# Access Compliance Report

## Public Rights-of-Way

### (Curb Ramps)

Intersection ID: 42669	Main Street: THORNHAVEN_CT	Cross Street: WALLACE_CABIN_DR	Location: SE
ADA ID: 51586543462C	Ramp Type: PerpDiag	Initial Pass/Fail: Fail	Overall Compliance: No
			Severity Score: 18.75

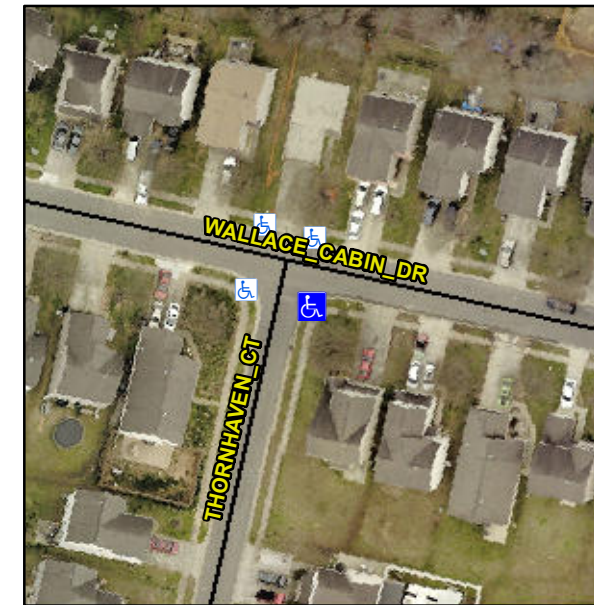
**R304.5.1, R304.5.3**

Compliance	Description	Data	Compliance	Description	Data
N/A	Ramp Length (in)	49.5	Yes	Ramp Slope (%)	6.0
No	Ramp Width (in)	33.0	No	Ramp XSlope (%)	2.9
N/A	Flare Type LT	N/A	N/A	Flare Type RT	N/A
N/A	Flare Slope LT (%)	N/A	N/A	Flare Slope RT (%)	N/A
N/A	Flare Traversable LT?	N/A	N/A	Flare Traversable RT?	N/A
N/A	Landing Length (in)	N/A	N/A	DWS Provided?	N/A
N/A	Landing Width (in)	N/A	N/A	DWS Contrast?	N/A
N/A	Landing Slope (%)	N/A	N/A	DWS Length (in)	N/A
N/A	Landing X Slope (%)	N/A	N/A	DWS Full Width?	N/A
N/A	Landing Curb? (Y/N)	N/A	N/A	DWS Offset (in)	N/A
N/A	Shared Landing?	N/A			
N/A	Gutter Ponding?	N/A	N/A	Gutter Slope (%)	N/A
N/A	Gutter Lip Ht (in)	0.5	N/A	Gutter X Slope (%)	N/A
N/A	Painted X Walk1?	No	N/A	Painted X Walk2?	No
	X Walk 1 Direction	To N		X Walk 2 Direction	To W
N/A	X Walk 1 Width (in)	N/A	N/A	X Walk 2 Width (in)	N/A
	X Walk 1 Slope (%)	3.9		X Walk 2 Slope (%)	1.4
	X Walk 1 X Slope (%)	0.1		X Walk 2 X Slope (%)	3.2

**Remove & Replace Curb Ramp With Two New Directional Ramps or Equivalent.**
